Model: Cattleya 20bin sorter stapler		Date: 15-Dec-99	No.: MA831001
Modified Article: Parts catalog correction		Prepared by: H. Matsui	
From: Technical Service Dept., GTS Division			
Reason for Modification:	<input checked="" type="checkbox"/> Parts catalog correction	<input type="checkbox"/> Vendor change	<input type="checkbox"/> To meet standards ()
	<input type="checkbox"/> To facilitate assembly	<input type="checkbox"/> To improve reliability	
	<input type="checkbox"/> Part standardization	<input type="checkbox"/> Other

Model: Cattleya 20bin sorter stapler		Date: 31-Jan-00	No.: MA831002
Modified Article: Parts catalog correction		Prepared by: H. Matsui	
From: Technical Service Dept., GTS Division			
Reason for Modification:	<input checked="" type="checkbox"/> Parts catalog correction <input type="checkbox"/> To facilitate assembly <input type="checkbox"/> Part standardization	<input type="checkbox"/> Vendor change <input type="checkbox"/> To improve reliability <input type="checkbox"/> Other	<input type="checkbox"/> To meet standards ()

Model: Cattleya 20bin sorter stapler		Date: 07-Dec-00	No.: MA831003
Modified Article: Grip Assembly		Prepared by: H.K.	
From: Technical Servi

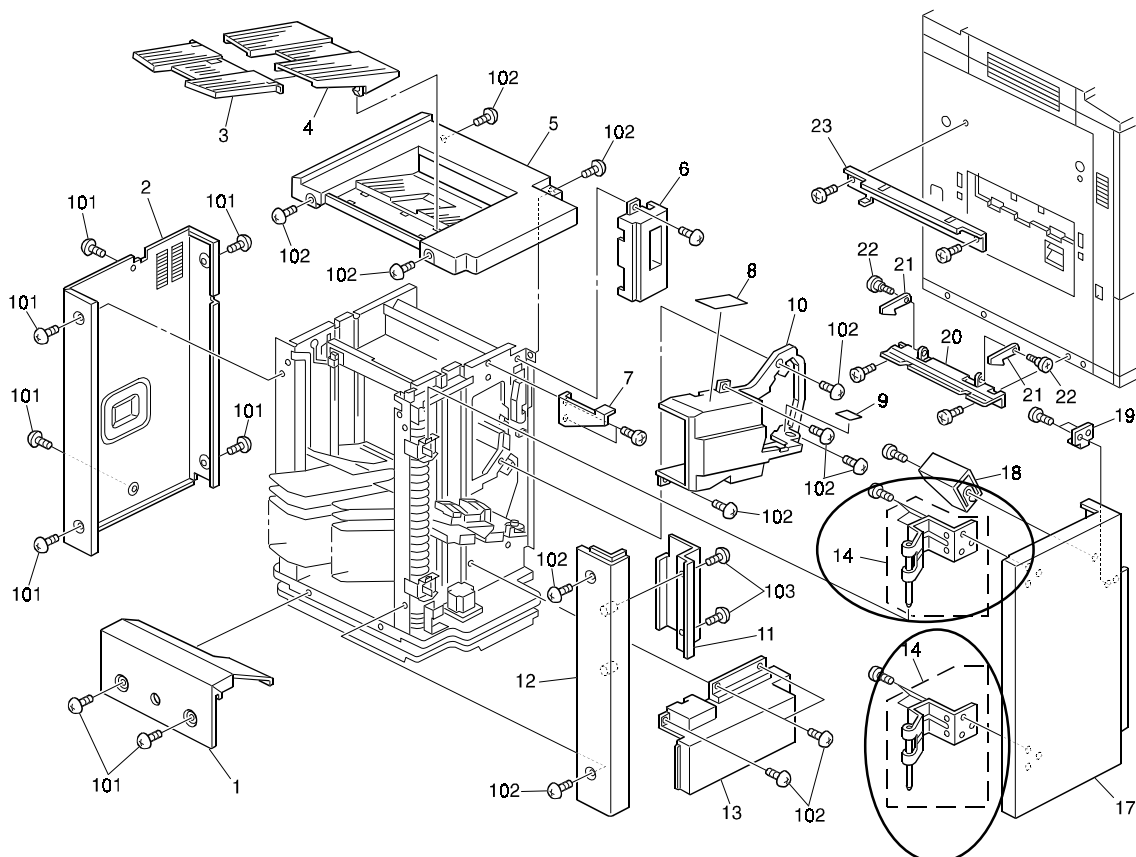
Incorrect part number	Correct part number	Description	Q'ty	Int	Page	Index	Note
A6641875	A8312562	Joint Arm	1-1		3	21	
A6976200	A8314511	Stud screw – M4	1-1		3	22

1. Index callout # for P/No.A8312562 and A8314511 were incorrect. Index callout # for these two items should be #21 and #22. (Please refer to the previous MB #MA831001 issued on Dec. 15. 1999)
2. P/No. A8311645 (Hinge Bracket : callout #14) is available only as an assembly. Therefore, callouts #15 and #16 should be deleted. Please replace the illustration with the following correct one:

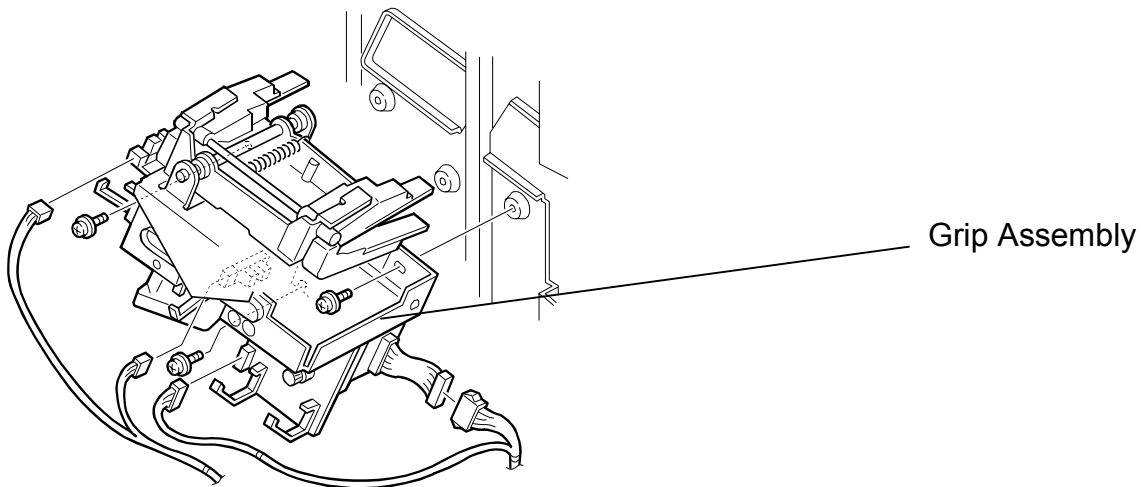
Old part number	New part number	Description	Q'ty	Int	Page	Index	Note
	A8214400	Grip Assembly	1		5	#*

As per field request, the grip assembly has been registered as a spare part.

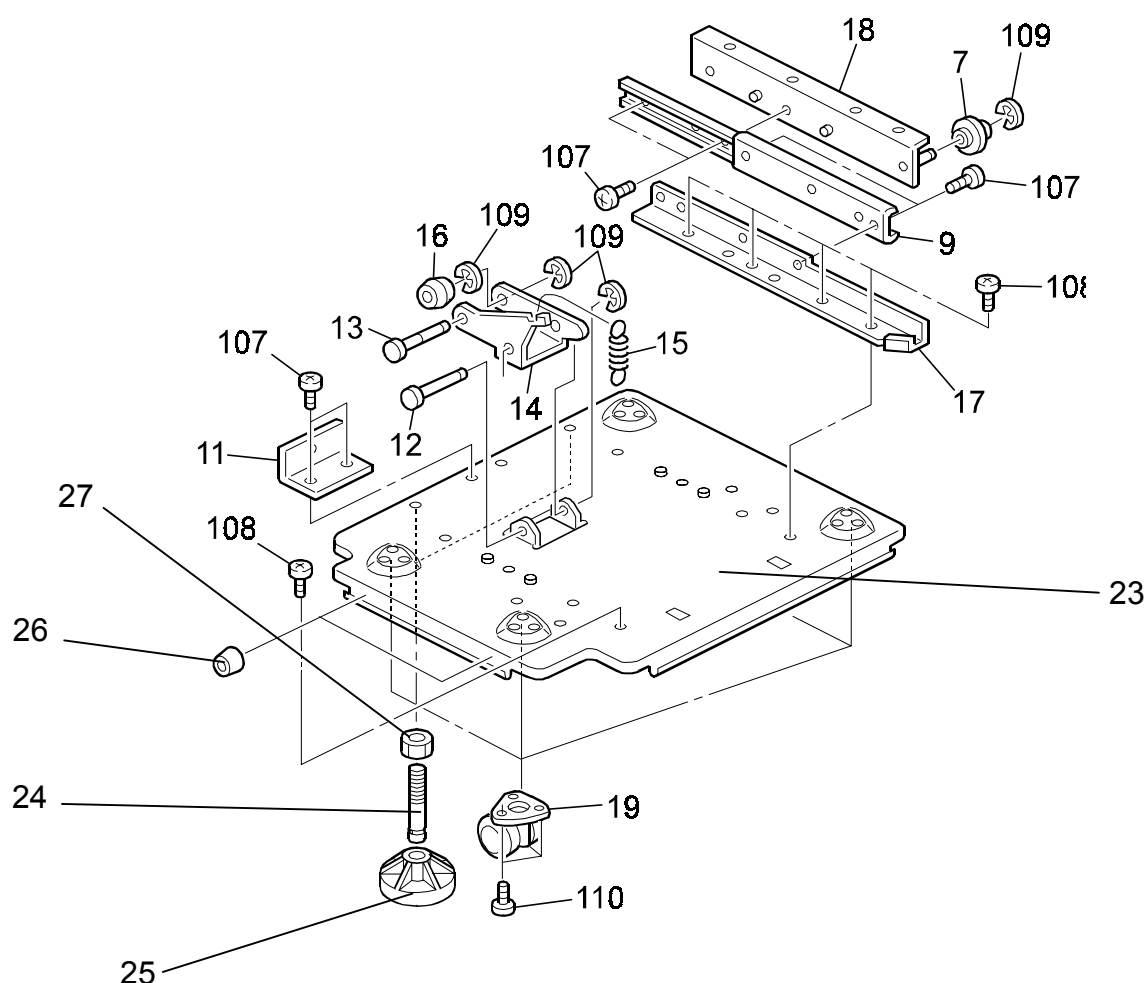
New part number	Description	Q'ty	Int	Page	Index	Note
A8311552	Base Plate - Lower	1	-	29	23	*1
A8314521	Adjusting Shaft	2	-	29	24	*2
A6816122	Stand Adjuster	2	-	29	25	*2
A8316522	Cushion – 10 x 18	2	-	29	26	*2
08049050	NUT M8	2	-	29	27	*3

*1: The call out number was missing.

*2: The illustration was missing.

*3: Newly registered item
